SERVICE BULLETIN

ENGINE – FUEL AND CONTROL – TO PROVIDE A NEW ELECTRONIC ENGINE CONTROL (EEC) WITH THE
SCN9A SOFTWARE CONFIGURATION AND HARDWARE CHANGES TO ADDRESS NACELLE DRAINAGE
REQUIREMENTS – CATEGORY CODE 3 – MOD.ENG-73-0052

V2500-ENG-73-0052

Location of Electronic Engine Control (EEC)
Fig.1

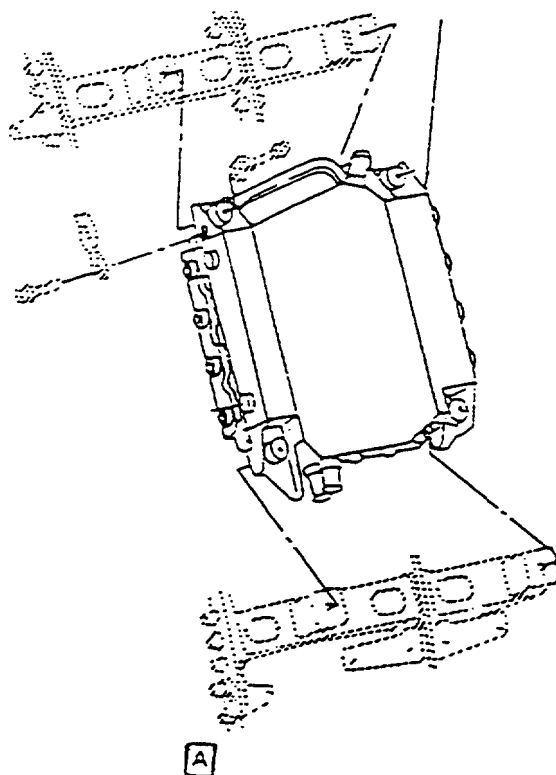
REMOVE THE 2A2989
ELECTRONIC ENGINE
CONTROL AND INSTALL
THE 2A3098 ELECTRONIC
ENGINE CONTROL (1 off)
